HERITAGE IMPACT ASSESSMENT

Property Address: Marshalls Manor, High Street, Cuckfield, Haywards Heath,
RH17 5EL

Report Date: 6th October 2022
Rev 2 – Addendum Added 13th May 2026

ADDENDUM 1 – 13th May 2026

Drawings referenced: **21072-P-03**

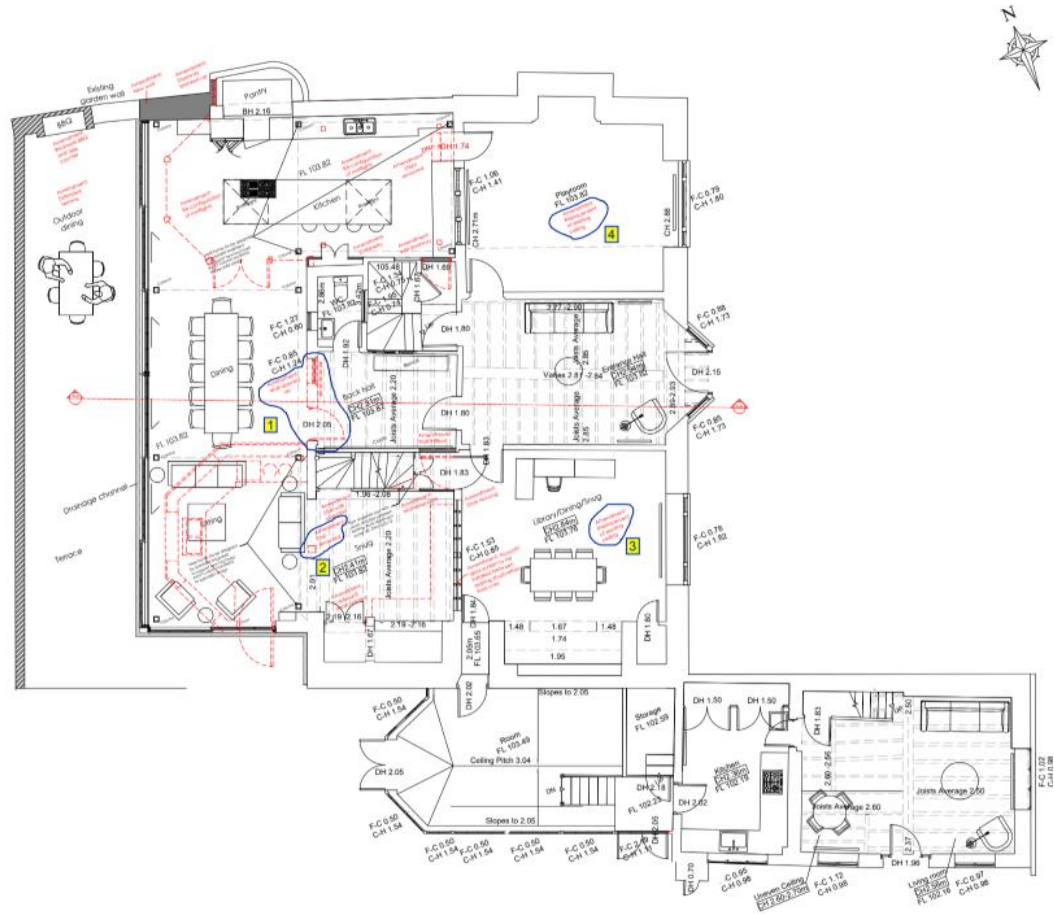
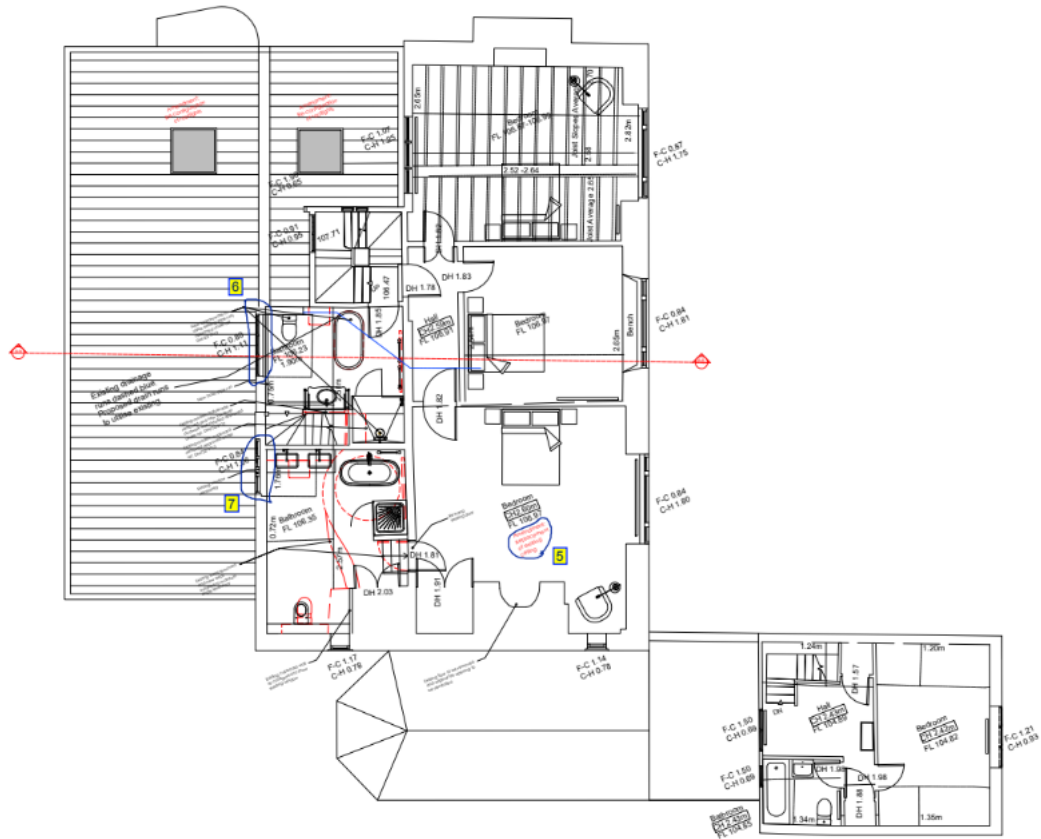
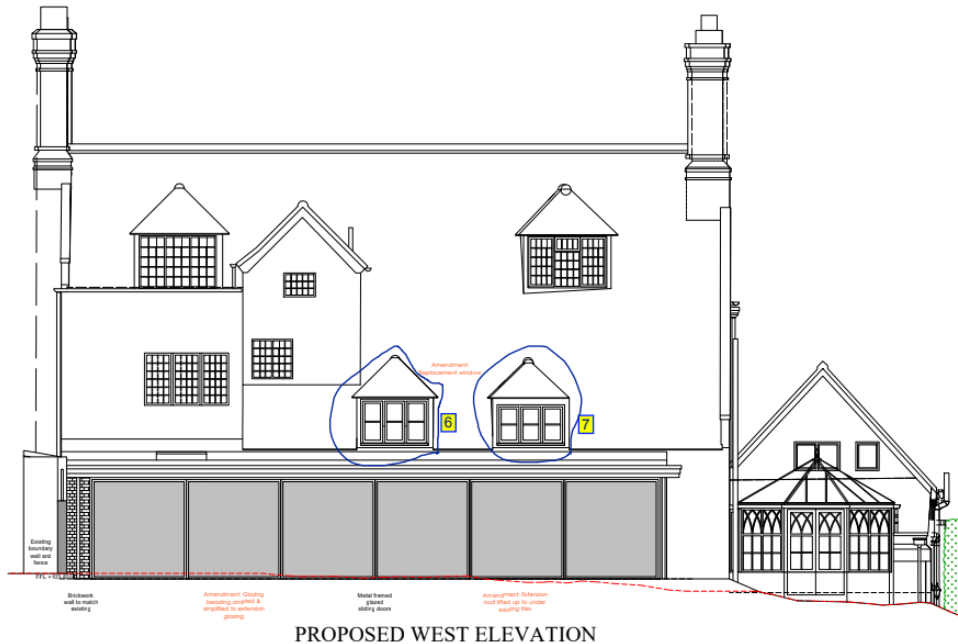
1. Opening in existing wall
2. Removal of existing post
3. Removal of existing ceiling
4. Removal of existing ceiling
5. Removal of existing ceiling
6. Replacement of existing window
7. 'Re-instatement' of existing window

Item 1 involves opening the brick wall rear of the outshot element of the property. Much of the structure of this element is modern, and probably dates to the mid 20th century at the earliest. Whilst technically covered by the provisions of the listing, its removal cannot be considered contentious in and of itself. There is no loss of comprehension as regards the remainder of this part of the building.

Item 2 involves the removal of a single timber post likely installed in the 1980s/90s to support an opening within the existing wider kitchen area. The impact of the removal will open a question as to the provision of support to the opening if the post is indeed removed. The removal is not contentious. The method of support in its place must be considered prior to consent and form part of that consent

Items 3-5 involve the removal of historic ceilings and we are not minded to offer recommendations to consent to these works.

Items 6 & 7 refer to alterations to existing consents. The previous consent was to match the dormers. The new proposal is to replace the existing glazing to both dormers to better compliment glazing in other parts of the building. This will result in the loss of existing glazing to these parts. In terms of impact, the windows are not matching and are both relatively modern in date

Neither of the windows are of particular heritage significance. They are proposed to match more closely the windows to the front dormer elements:

The alterations to existing consents are relatively minor.
